Subject: Minutes of the 48th Protection Sub-Committee Meeting.

*48th Protection Sub-Committee Meeting (11th October, 2023)-MoM***Contents**

Minutes of the
48th Meeting of Protection Sub-Committee (PSC) of
Northern Regional Power Committee

DR of 220 KV Mohana(HV)-Sonipat(PG) (end) (HVPNL) Ckt-1

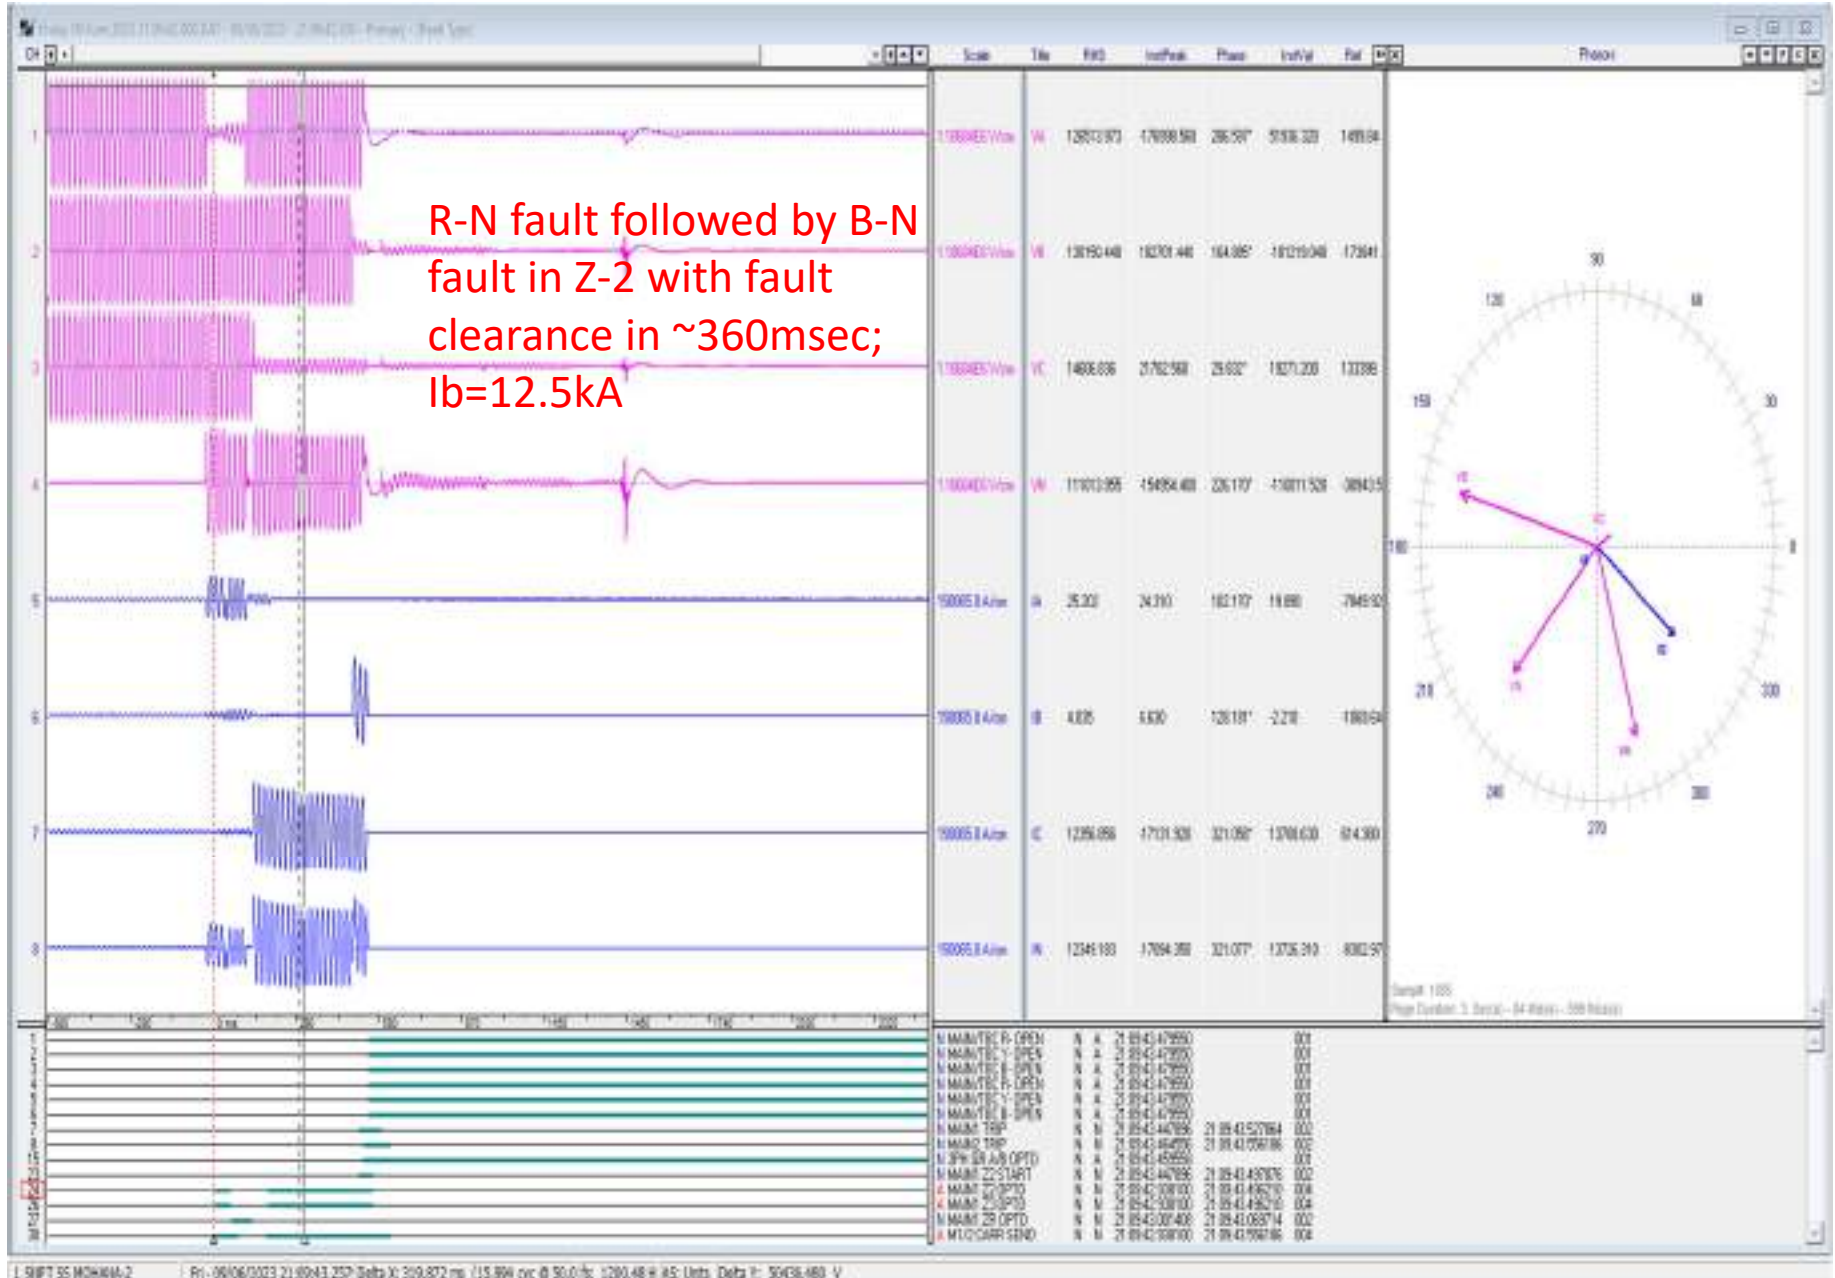
As reported, fault occurred due to damage of CT at Mohana end. What was the fault distance from Sonipat (PG) end, as it was sensed in Z-1?

DR of 125MVA bus reactor at Bhadla(RS)

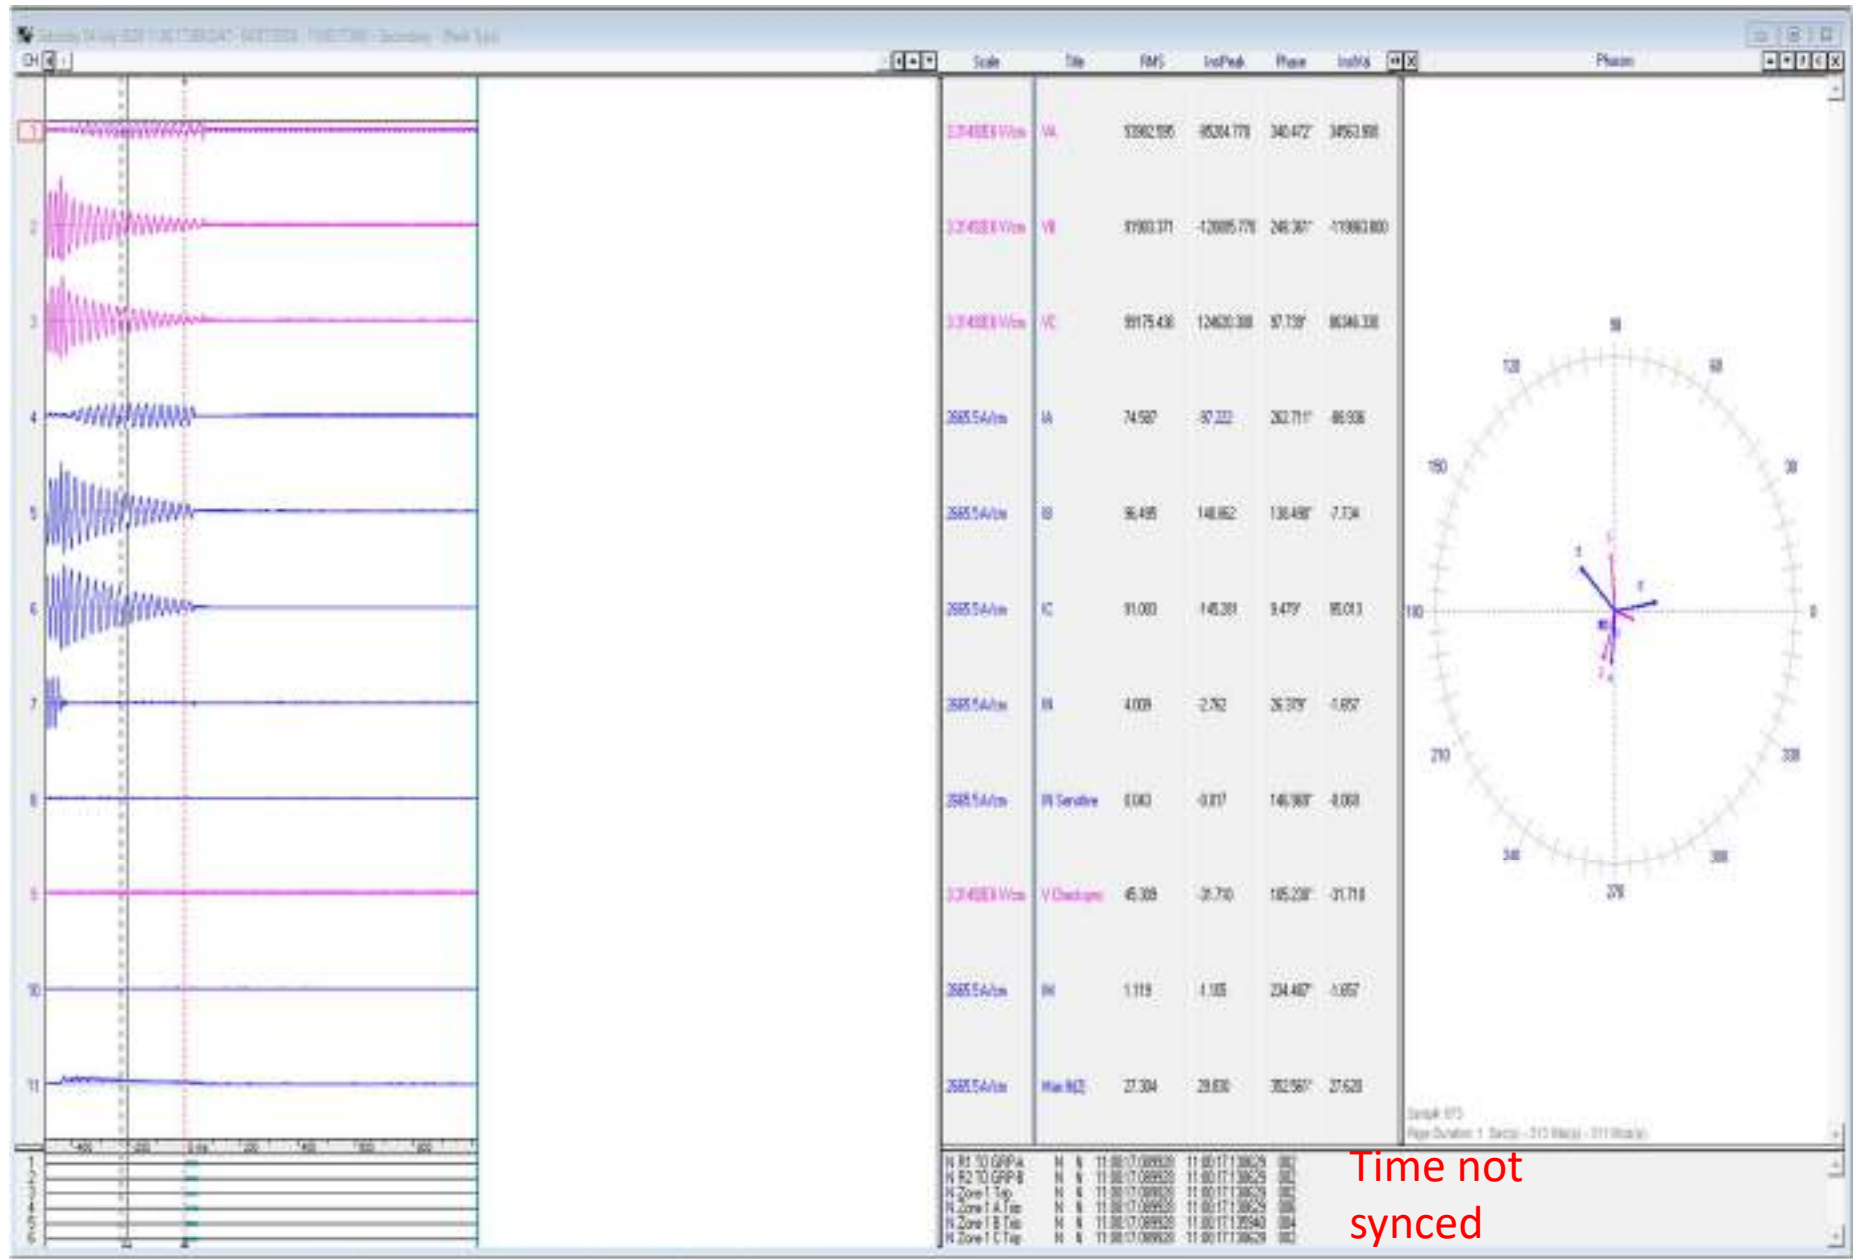
Time not synced

DR of 220kV Ratangarh400(end)-Ratangarh220 (Raj) ckt-1

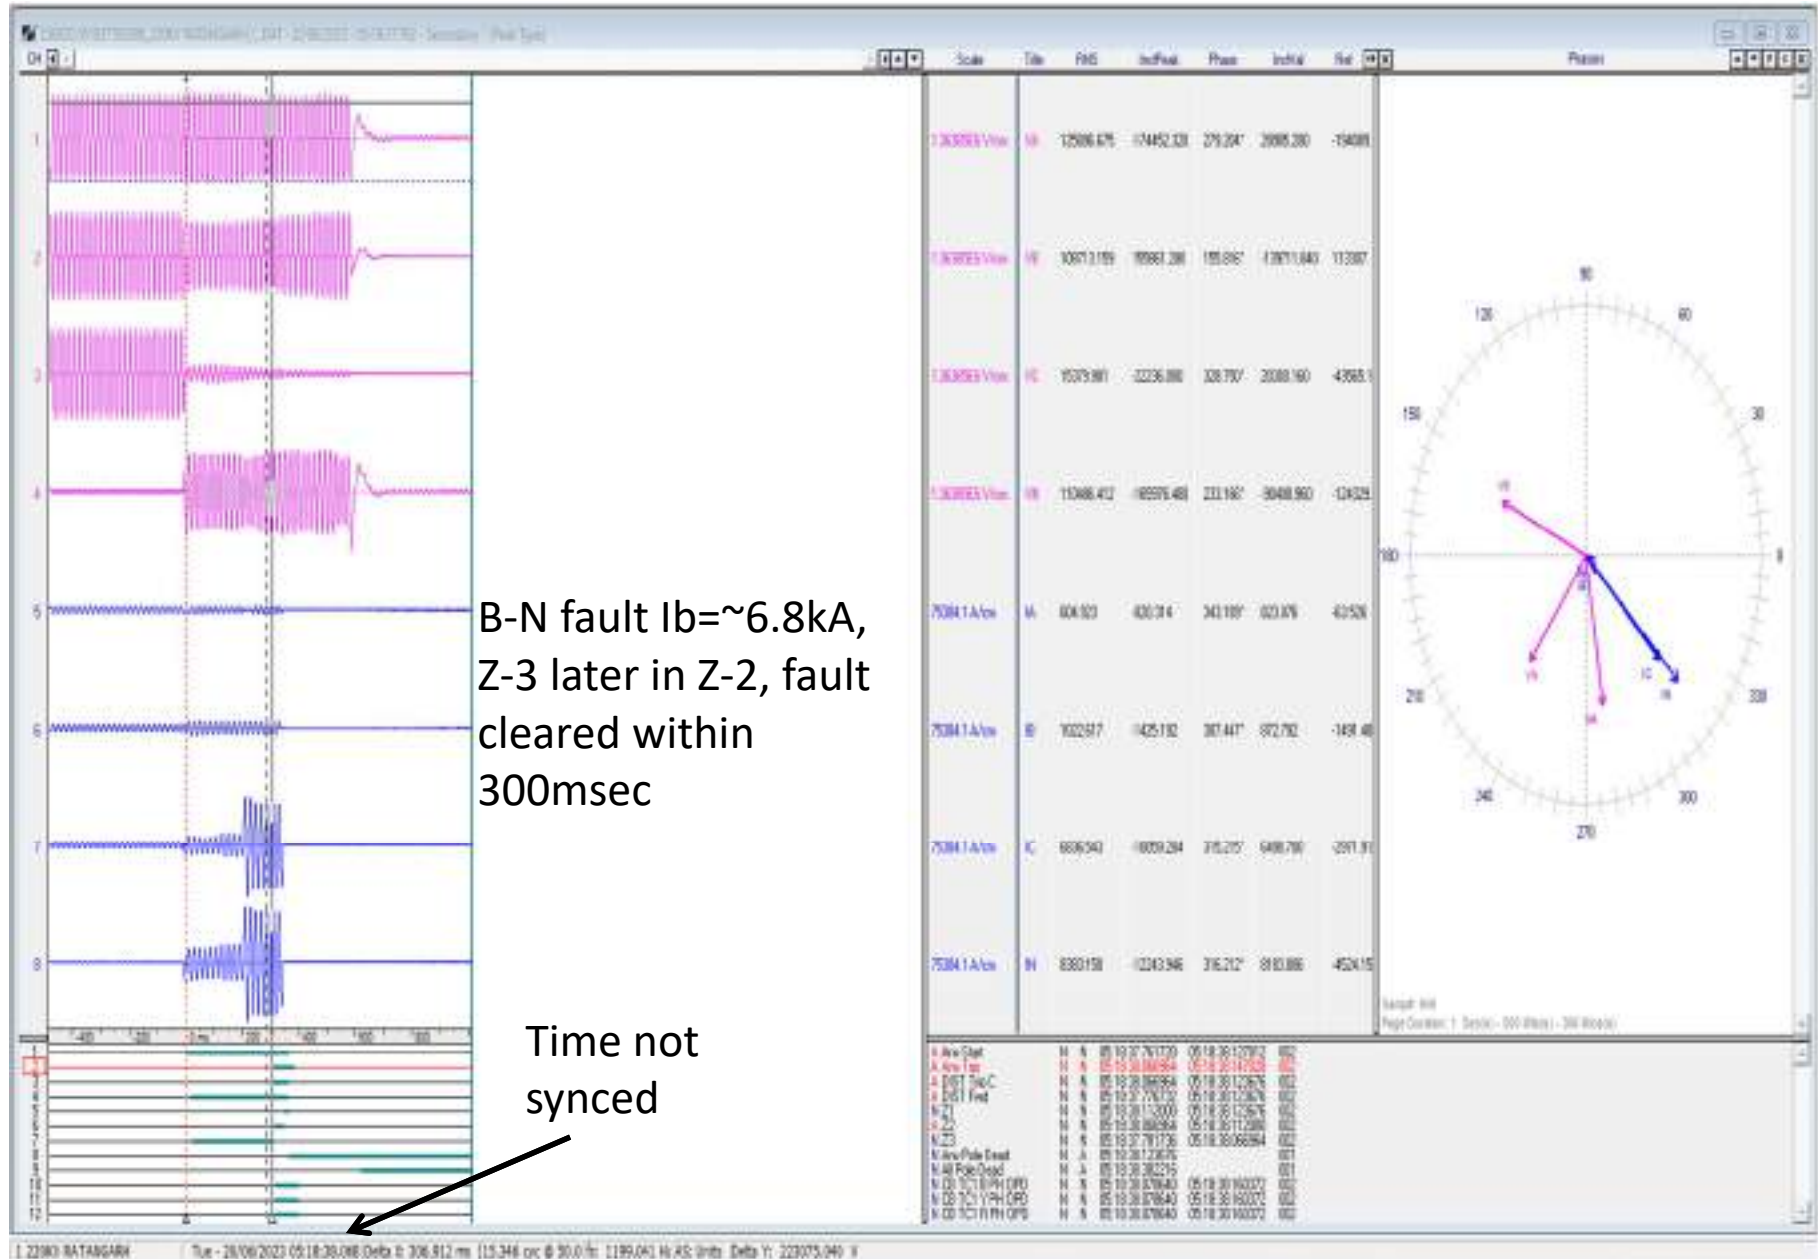
Phase sequence are not correctly configured. As per PMU & Ratangarh220 DR, fault in B-phase.
